ATTACHMENT I

ST. LUCIE UNIT 2

Marked-up Technical Specification Page:

3/4 4-12 (plus insert)

Figure 3. Predicted Extent of Batwing Wear
for 40-Year Life of Steam Generator

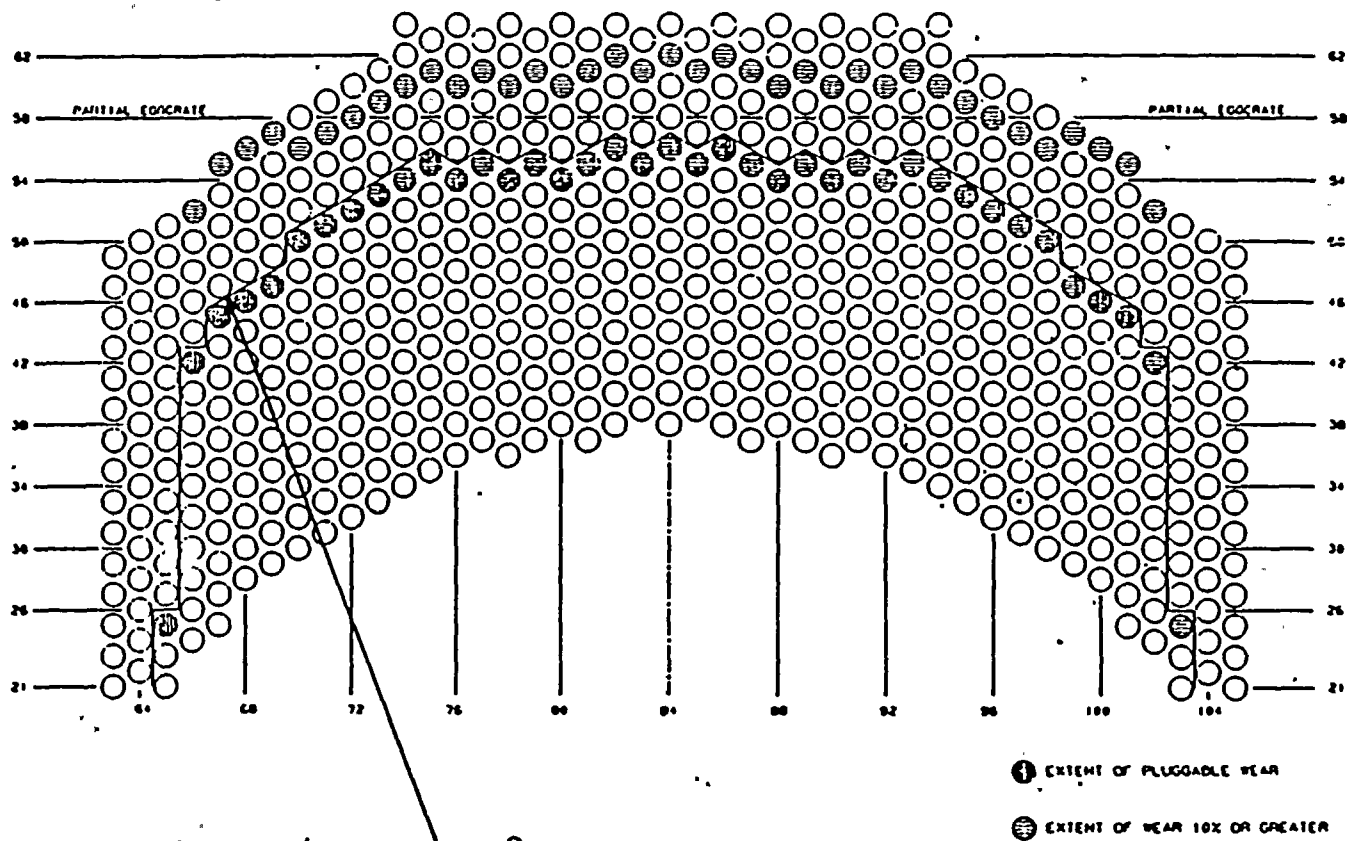
The tubes within the projected batwing wear region are as deep as row 56 in from the stay cylinder (Figure 3). Previous inspections resulted in plugging of 200 tubes in the A steam generator and 145 tubes in the B steam generator: conservative plugging limits were used in the affected region (< 40% throughwall). The proposed inspection pattern will include all unplugged tubes within the projected 40% wear region, as noted on Figure 3, with a minimum of two rows of indication free tubes at the periphery of the inspection pattern. Thus, the affected region of tubes will be geometrically bounded by an inspection pattern with at least two rows of indication-free tubes at the periphery of the pattern. Similar bounding patterns have been used in other steam generators for corrosion and wear indication which were associated with geometric design features. This geometric approach will effectively monitor progression of batwing wear and will provide additional verification of the wear model for future inspections.

The results from the geometrical bounding pattern will be considered to fall into a population of tubes which are atypical of the remainder of the steam generator tubes and will not be included in the St. Lucie Unit 2 Technical Specification S¹ tube population. All other previously identified degraded tubes, tubes in historically suspect areas and a representative statistical sampling of the remainder of the tube bundle will be included in the S¹ tube sample.

d. Tubes within the following region may be excluded from the first sample:

All non plugged tubes contained within the bounds of line 66 to line 102 will be inspected nominally 10 to 11 rows in from the untubed region adjacent to the tube sheet stay cap. All non plugged tubes in lines 65 and 103 will be inspected from row 21 to row 25.

No credit shall be taken for these tubes, if all tubes within the region are inspected, in meeting the minimum sample size requirements.
